Re: Draft Final Remedial Design/Remedial Action Work Plan, LHAAP-17 Burning Ground No. 2/ Flashing Area, Group 2, Longhorn Army Ammunition Plant, Karnack, Texas, March 2019

**Response to Comments on
Draft Remedial Design / Remedial Action Work Plan
LHAAP-17 Burning Ground No. 2 / Flashing Area, Group 2**

Reviewer: Mr. Richard Mayer, USEPA

Figure 4-1

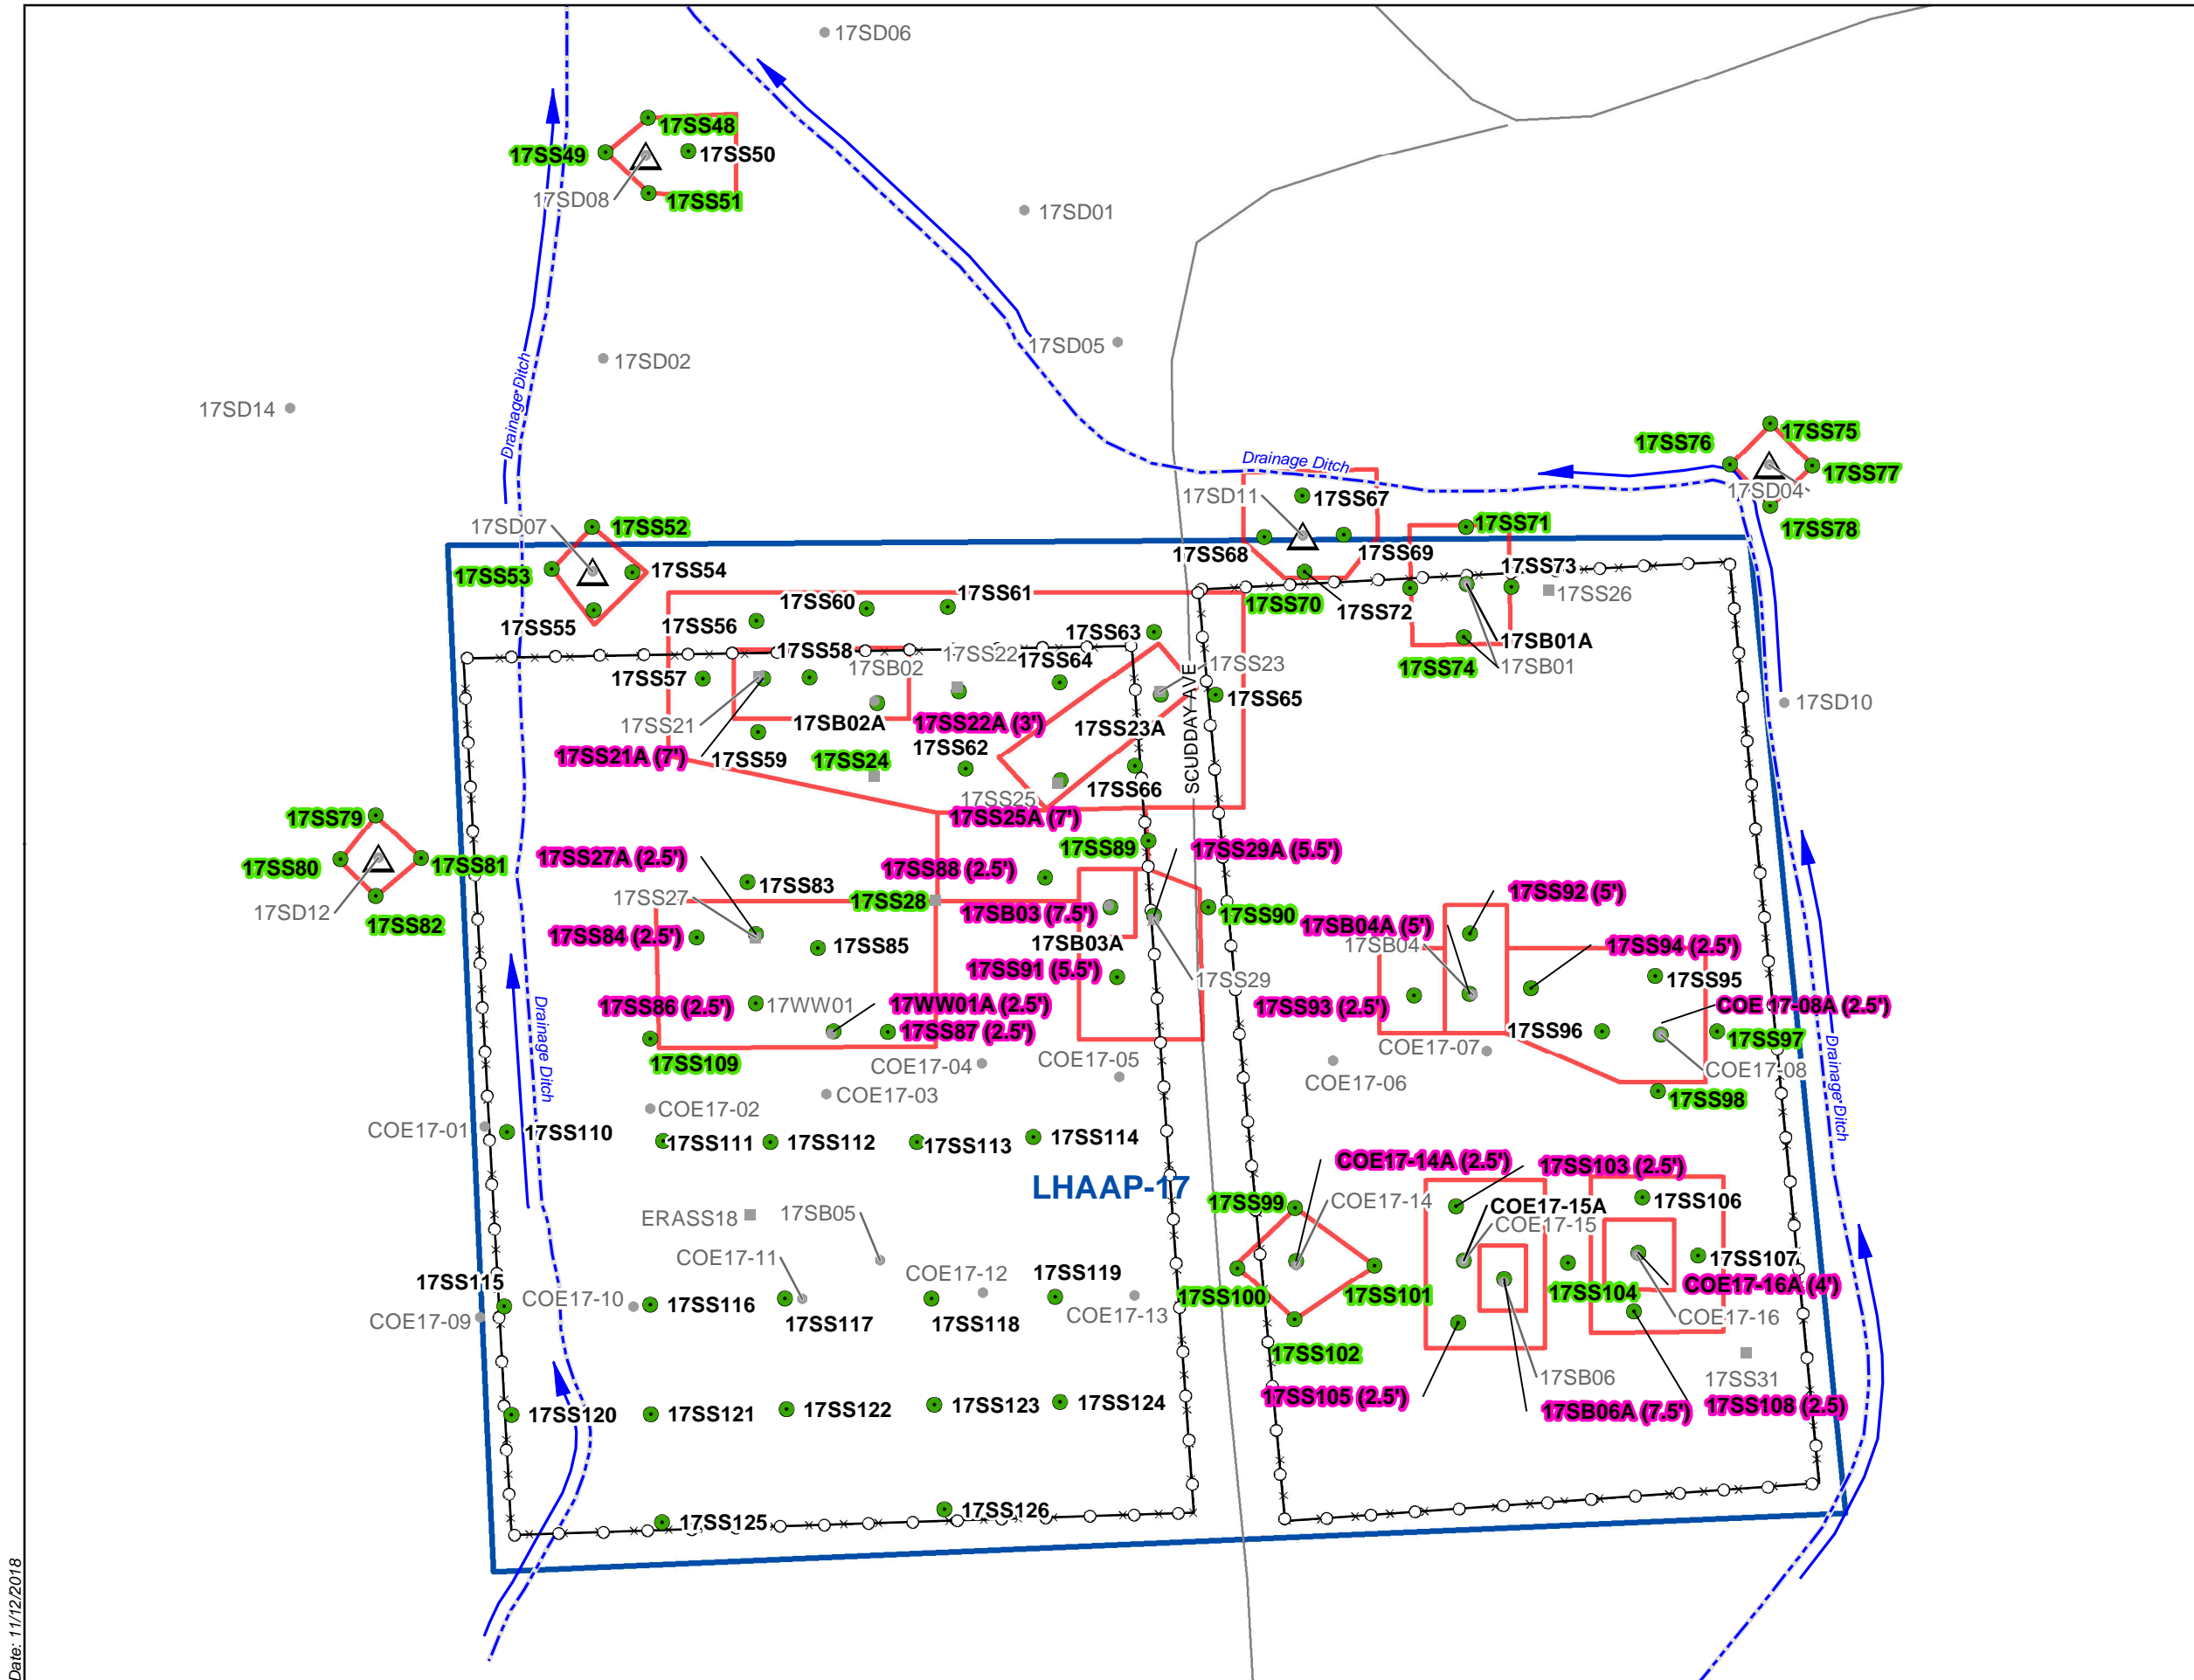
17.	Figure 4-1	This is very helpful figure. Please change one of the greens to a different color (too similar). The greens look different on the pdf but not on the printout.	C	Figure 4-1 has been revised as requested.

FIGURE 5-2
 Groundwater Extraction Process Flow Diagram
 Remedial Design / Remedial Action Work Plan
 LHAAP-17

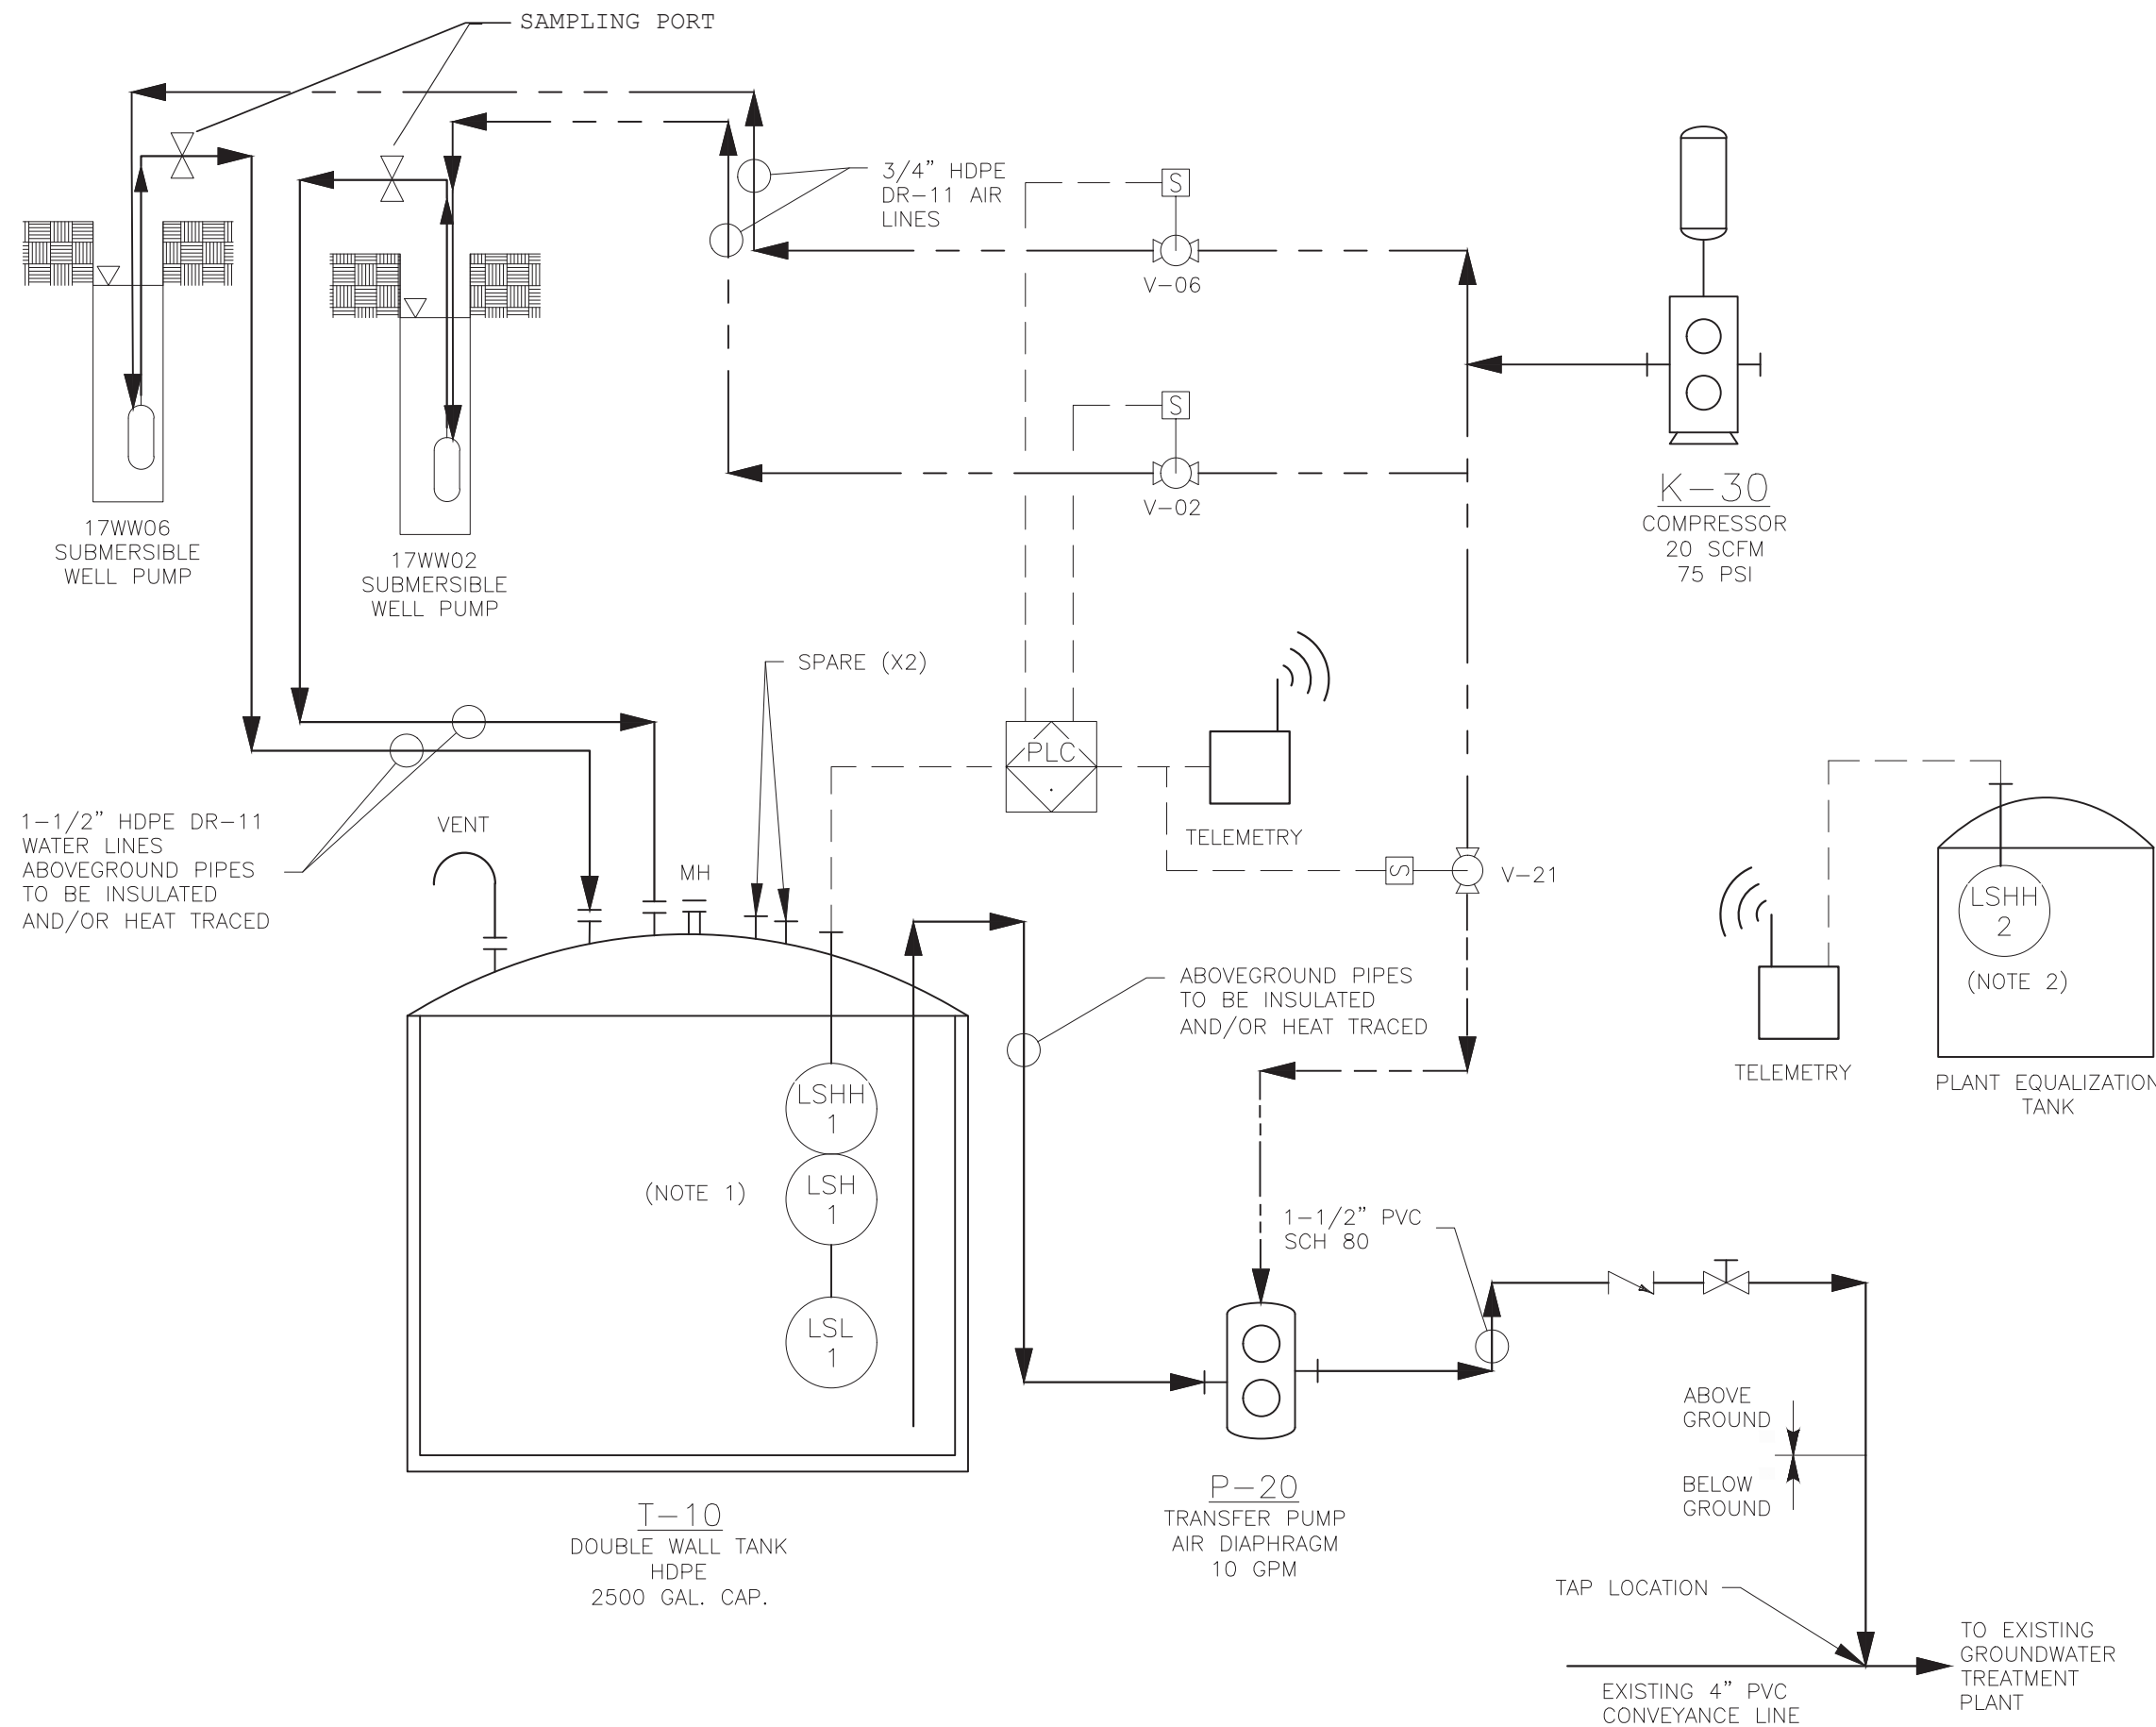
6.	Figure 5-2	The Figure indicates two places in the flow diagram where telemetry will be used. The narratives in sections 5 and 7 do not mention if this will be used. Please clarify	C	The telemetry shown on Figure 5-2 is explained in Note 2 on the figure as a control to close the air line operating the transfer pump (pumping water from LHAAP-17 to the GWTP) if the level in the equalization tank at the GWTP trips the high-level alarm. If the transfer pump remains shut down long enough, the high-level alarm in the holding tank will trigger the pumps in the extraction wells to shut down as well. Discussion of the telemetry connection has been added to Section 5.4.2.

18.	Figure 5-2	Between V-21 and P-20 the line looks like water line. Should this be air line? Is that a valve with port or just on/off valve after P-20? Would a sample port also be useful at that location (blended)? If 17WW01 is included, would it also have a sample port?	C D C	Figure 5-2 has been revised to show the referenced line as an air line. The valve shown is an on/off valve only. There will be sample ports for each extraction well, so collecting a blended sample does not really have value since the water will ultimately be mixed in the equalization tank at the GWTP with water from LHAAP-18/24. If 17WW01 is added as an extraction well, it will be set up exactly as the other wells are shown. A note has been added to the figure stating that 17WW01

Comment No.	Section, Page ref.	TCEQ Comment	C, D, E, or X¹	Response	A or D²
				may be added using the same design based on the results of the baseline sampling.
